PIC16C73A Rev. A Silicon Errata Sheet

The PIC16C73A (Rev. A) parts you have received conform functionally to the Device Data Sheet (DS30390E), except for the anomalies described below.

FIGURE 1: SCK PULSE VARIATION USING TIMER2/2

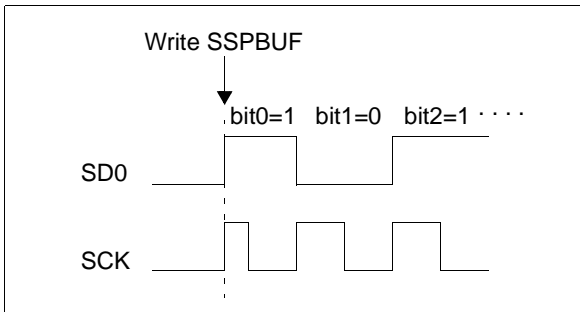
When the SPI is using Timer2/2 as the clock source, a shorter than expected SCK pulse may occur on the first bit of the transmitted/received data (Figure 1).

To avoid producing the short pulse, turn off Timer2 and clear the TMR2 register, load the SSPBUF with the data to transmit, and then turn Timer2 back on. Refer to Example 1 for sample code.

FIGURE 1: WRITES TO TIMER1 (EXTERNAL CLOCK/OSCILLATOR MODE)

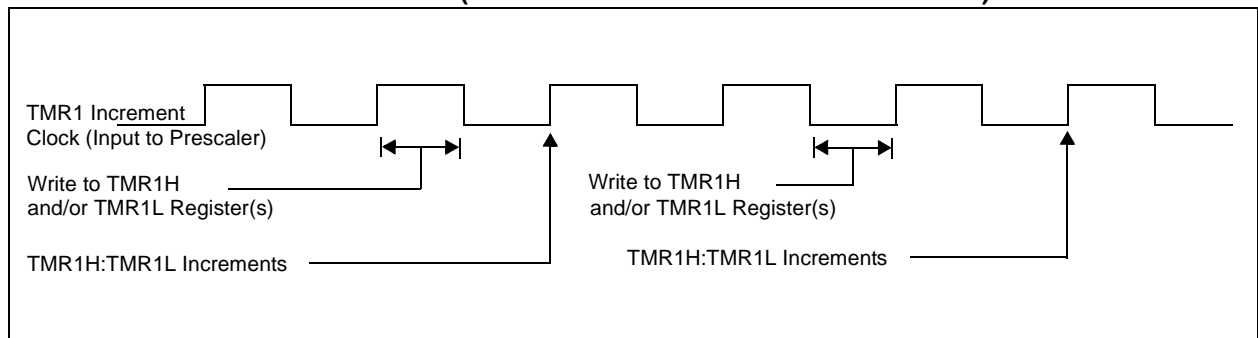
The operation of Timer1 needs some clarification when the timer registers are written when the TMR1ON bit is set.

The internal clock signal that is the input to the TMR1 prescaler affects the incrementing of Timer1 (TMR1H:TMR1L registers and the Timer1 prescaler). When the Timer1 registers are NOT written, the Timer1 will increment on the rising edge of the TMR1 increment clock.

When the TMR1H and/or TMR1L registers are written while this clock is high, TMR1 will increment on the next rising edge of this clock.

When the TMR1H and/or TMR1L registers are written while this clock is low, TMR1 will not increment on the next rising edge of this clock, but must first have a falling clock and the rising clock, for TMR1 to increment.

Figure 1 shows the two cases of writes to the TMR1H and/or TMR1L registers. Due to the V_{IH} and V_{IL} thresholds on the oscillator/clock pins, external Timer1 oscillator components, and external clock frequency, the Timer1 increment clock may not be of a 50% duty cycle.

The TMR1 increment clock is out of phase of the T1OSO/T1CKI pin by a small propagation delay.
